Land South Of 63, Creek Road, March, Cambridgeshire

Erect 1 dwelling (2-storey 3-bed)

Officer recommendation: Refusal

Front Elevation (W)

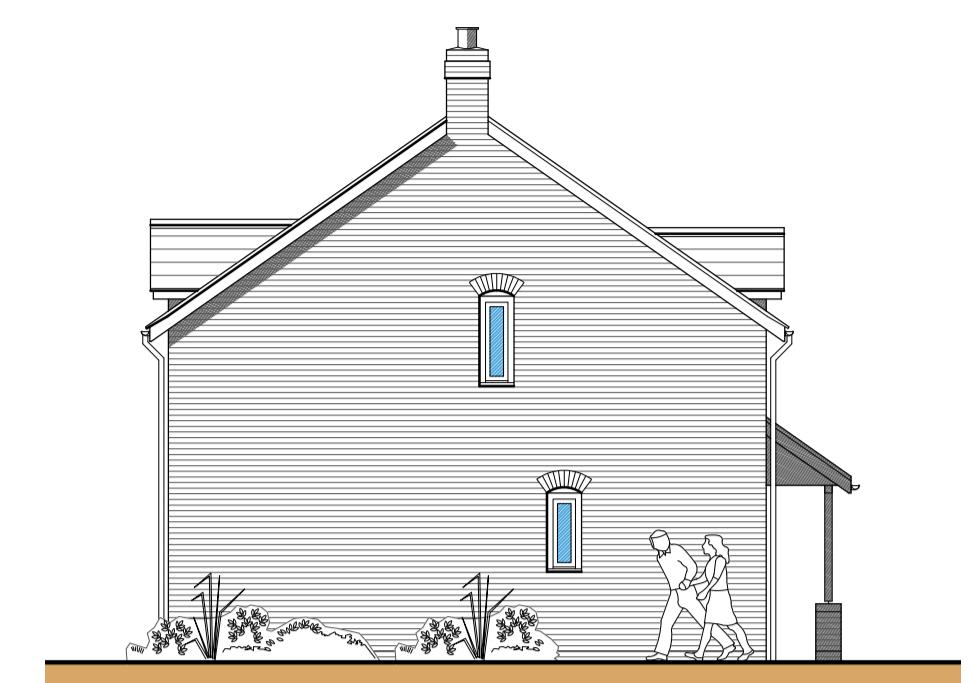
- 10.13. The windows to the front elevation of the property open onto a bathroom and bedroom. It would be reasonable to expect/require the bathroom window to be obscure glazed, however the bedroom window would overlook the gardens of the properties on the opposite side of the access drive from a distance of approximately 6 – 6.5 metres, which could therefore result in an impact on the privacy of those gardens. To the rear of the building, there are two first-floor bedroom windows looking out over the garden of the property, approximately 6m from the rear boundary of the site, with private residential gardens beyond. The boundary is currently screened through existing trees, which are located within the neighbouring land and their retention could not therefore be secured through condition on the current application.

10.15. In this instance, the proposal would result in a dwelling in very close proximity to its access road, along which at least 5 other dwellings are accessed. Although the front of the property houses the kitchen and hallway rather than the living room/dining room areas, this will still result in a poor relationship with the vehicular traffic using the driveway, particularly given the lack of separation of vehicular traffic from the site due to the absence of a dedicated footway.
